**ADDENDUM NO. 1**  
**TO THE**  
**REQUEST FOR INFORMATION**  
**FOR THE**  
**Bloomington Hospital Re-Use (BHRU) Infrastructure & Site Engineering**  
**Phase 1 East Project**

**Addendum No. 1 Issue Date:** March 18, 2021

## Study Area

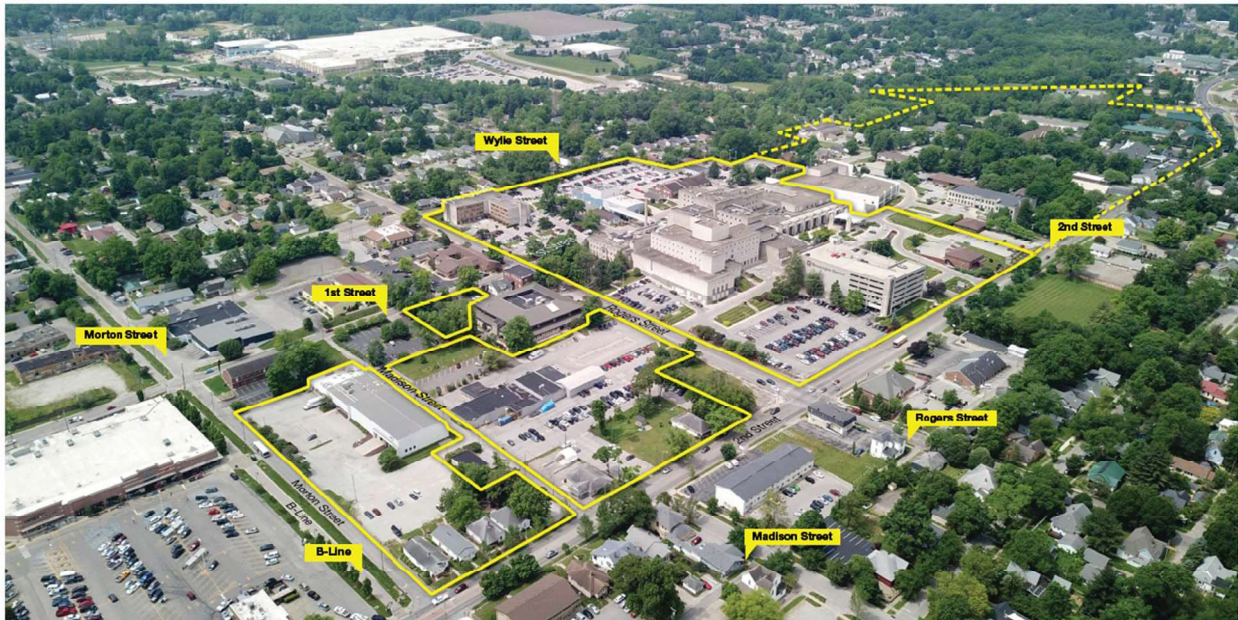
(Q) Within Phase 1 East's project area several properties within the Study Area illustrated on page 40 of the Master Plan are not shown as being redeveloped (some buildings to remain), do you anticipate this changing as the Project moves forward?

(A) The areas highlighted in this graphic (see below image from the Master Plan) provide a general idea of the parcels anticipated to be owned and redeveloped by the City; however, it is likely that the parcels illustrated on this graphic will not precisely reflect the final project scope that moves forward. Some parcels within the Phase 1 East project area are not anticipated to be acquired by the City (e.g., northwest corner of W 1<sup>st</sup> St/S Morton St intersection), others may be adjusted through property negotiations (e.g., Centerstone), and other acquisitions are being pursued (e.g., the parcel in the southeast corner of W 2<sup>nd</sup> St/S Rogers St intersection). The City will provide more detailed parcel ownership and transfer data following the award of this RFI.
